## Retirement Living

Re: Response to Submissions Report Modification application MP 08\_0260 for Cardinal Freeman Village at 137 Victoria Street, 4-10 Clissold Street and 102-102A Queen St, Ashfield

View 1 -Looking toward Chapel and Building 4 from top of stair

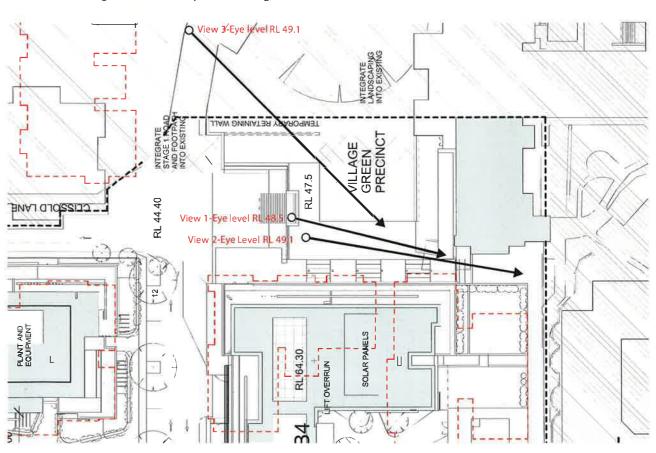
The key difference between B4 and Q2/3 is the addition of a setback top floor level. The design of the new roof element is similar to that of B1 in that it is a recessed top floor with pronounced oversailing roof. Furthermore, on the eastern facade, it appears that a free-standing solid 'wrap-around' architectural feature has been included that would stand proud of the set back and roof - although as the roof drwgs (DA2127d and DA2126e) show different roof designs the exact proposal is unclear. The CGI provided showing the relationship of B1 and the Chapel is instructive. However, it appears to be taken from a 1st/2nd floor level, rather than a pedestrian perspective. It perhaps would have been helpful if the sensitive vantage point, within the Village Green (eastern half) at natural eye level, was provided.

With specific reference to the relationship of B4 to the Chapel, your heritage Consultant Ms Lynch, states that as 'the higher component of B4 is set back from the eastern facade, which addresses the Chapel, and will not be readily perceived in views from pedestrian level in this location'. I agree with the principle of Ms Lynch's comments, however, this has not yet been demonstrated and I am concerned that the actual design of the proposed building form, where it projects towards the Chapel, may be visually dominant when viewed from a pedestrian perspective. As with B1, I am initially keen to hear your views on how you think this may be resolved and of course happy to work towards a solution.

We have nevertheless refined the design of the uppermost floor of Building 4 by deleting the architectural feature previously proposed on the eastern façade and changing the solid roof overhang to a pergola, as per Building 1. We have also undertaken additional studies of the relationship between B4 and chapel when standing in the Village Green to demonstrate the view from eye level. Three different viewing points have been illustrated. Please refer to:

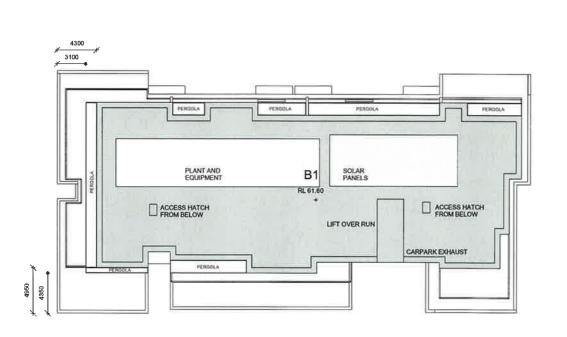
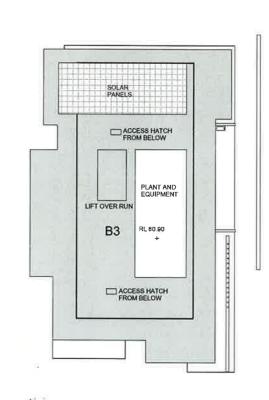
Where it faces Queen Street, the design of the top floor of B1 indicates a 2.2m set back with a pronounced oversailing roof (900mm set back). I am concerned, owing to the limited setback and roof design for the top floor that the building would be perceived as a full 5-storeys from pedestrian perspective at Queen Street. I also note the significant jump in height between the sunken 4-storeys of the RACF and the full height of B1 (see Section no.4 on drwg DA3105a). It may be beneficial if the top floor (where it faces Queen Street) was treated more recessively. I am initially keen to hear your views on how you think this may be resolved and of course happy to work towards a solution.

In response to these concerns we have redesigned the layout of two of the uppermost units in Building 1 to increase the setback of the top floor from Queen Street. These units, previously submitted in the application of October 2012 were a two-bedroom and a three bedroom unit. They are now proposed as 2 x two-bedroom units. This provides a 4.3m setback from the façade of the lower floor and ensures that that the

uppermost floor will recede from view. The roof of this top floor has also been set back further and redesigned as a pergola so that it is visually light and transparent while still fulfilling its sunshade function.
